Re: Restoration Bay  
Case Number: Z/LU-14-09-19  
Parcel: 33-30-15-00000-240-0100  
RFAI Response #1

**RESTORATION BAY**  
PINELLAS COUNTY, FLORIDA  
**EXHIBIT A - MULTI PURPOSE TRAIL**  
EXHIBIT

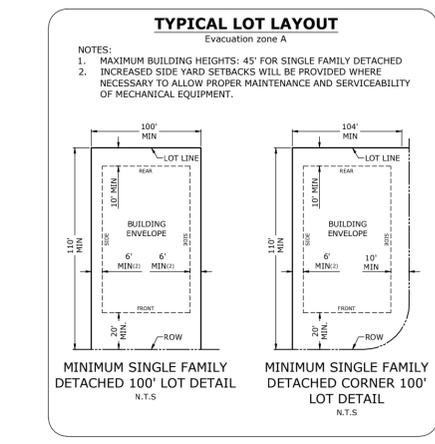
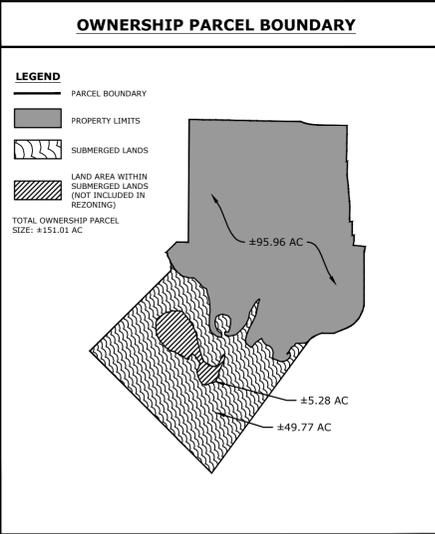
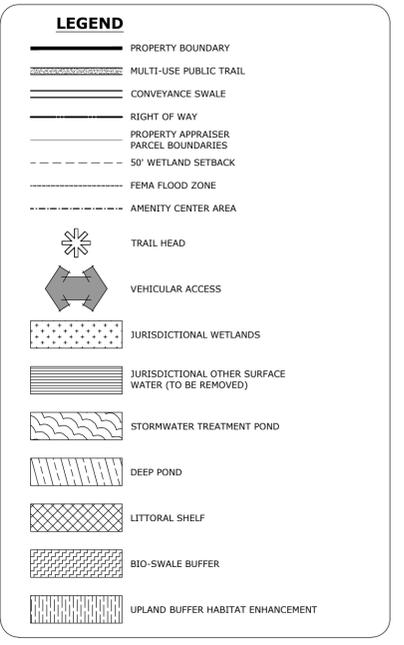
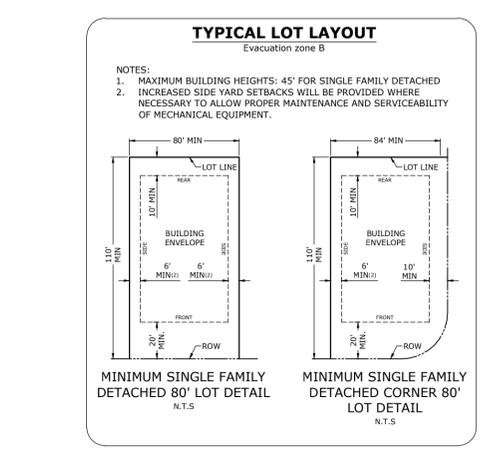
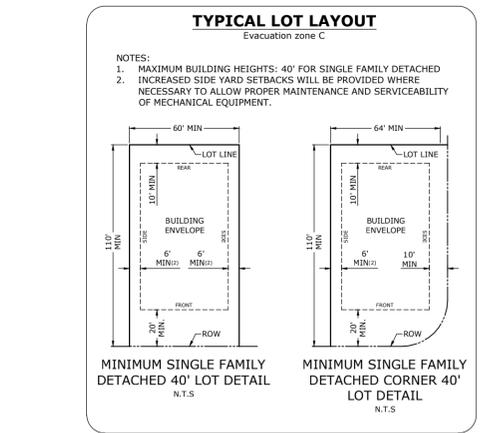
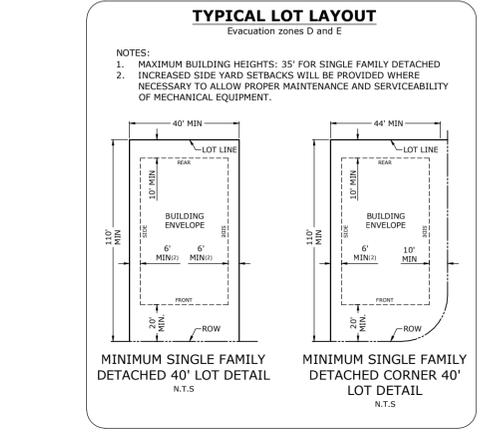
- 3. Staff Comment: The RPD zoning district requires that the district be master planned as a creative, walkable and context-sensitive community that responds to the surrounding land use pattern and preserves unique natural features. Therefore, the Development Master Plan should seek to set aside the more vulnerable areas of the site for preservation/open space uses. The current design does not achieve this, nor does it evaluate and compensate for the impacts of future sea level rise.**

6. **Staff Comment: When viewed in its totality, the proposed external stormwater treatment (while clearly beneficial to the area) comes at the expense of not setting aside the most vulnerable areas of the property for preservation/open space, and places residential development in these areas instead. On balance, the public benefit does not outweigh the overall impacts of the development and the loss of recreation/open space and preservation uses on the property.**

As stated above, the Applicant has proposed to utilize over 35 acres of the property for open/recreation space purposes, including the waterfront dwelling setback area to protect the most vulnerable portion of the project from potential storm impact, and a substantial multi-use trail around the entire development to improve public access to the County park and to the waterfront (public access which was not available previously and which cannot otherwise be provided by the County).

Importantly, these public benefits can be provided in addition to the brownfield and stormwater programs; they are not somehow precluded by the proposed development plan. To the contrary, the proposed plan carefully and creatively locates the low-density residential development in the center of the property, utilizing a substantial dwelling setback buffer from the coastal area and dwelling design standards appropriate for the coastal storm area (see, e.g., the City of St. Petersburg design standards program), provides a smart transition of lot sizes to shift density away from the waterfront, adds multimodal public access to the County park and the waterfront, implements a brownfield program to restore the environmentally-damaged golf course property, and provides the opportunity for on-site treatment of off-site, untreated storm water that has been a chronic historic problem dumping into Boca Ciega Bay.

## Former The Tides Golf Course Use Historical Financial Performance Total Revenues and Number of Rounds Played

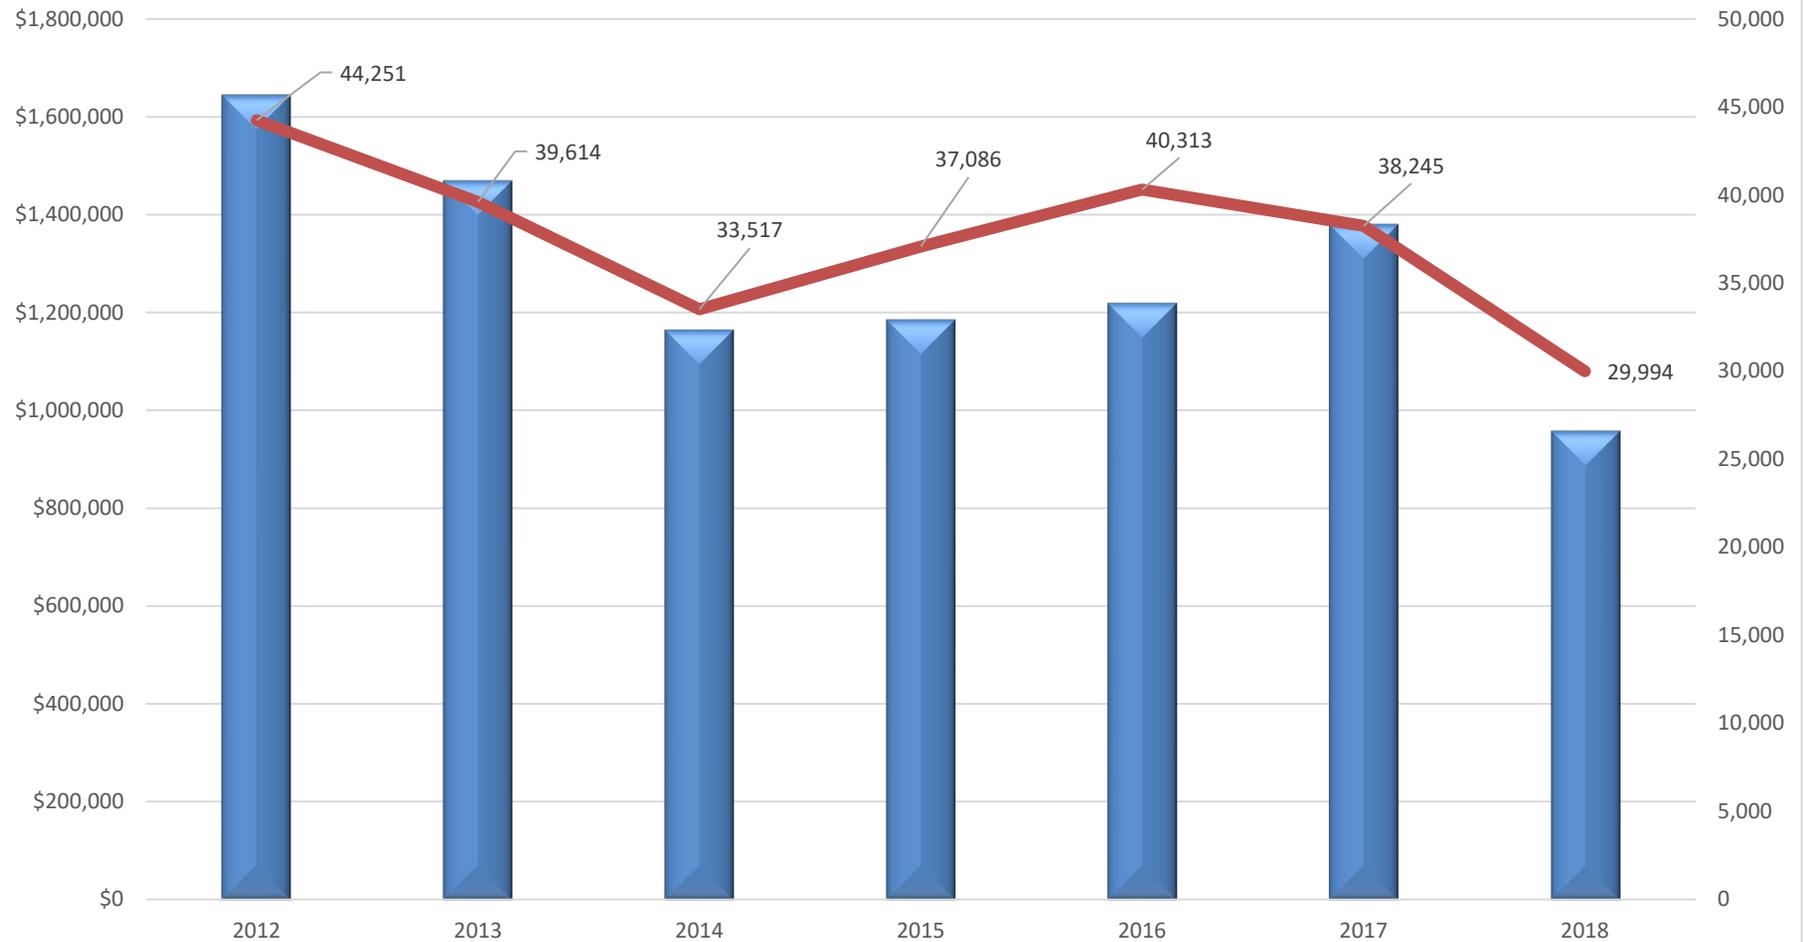
2. **Staff Comment: While the proposed Future Land Use map designation of Residential Low is generally consistent with the surrounding area, the locational characteristics of the category recognize that the more appropriate designation for areas within the 100-year flood plain is Preservation or Recreation/Open Space and that the Residential Low category is only appropriate if Preservation and/or Recreation/Open Space are not feasible, which has not been demonstrated by the applicant.**

While expressly reserving its position that the Applicant has no legal burden to prove that continued recreation/open space use is not “feasible” (as asserted by staff), the Applicant has attached a summary of the historical financial performance for the previous Tides Golf Course operation, including years of ownership prior to the Applicant and after the Applicant’s purchase of the property. The financial data demonstrates declining revenue, declining golf rounds played, and substantial losses annually for the entire 7-year period which pre-dated the final closure of the golf course business operation and demolition of the golf course building improvements, thus demonstrating that such recreation/open space business operation was not “feasible.” The County has no legal right or authority to mandate or to impose such continued financial losses upon any property owner or business under the guise of legitimate land use regulation.
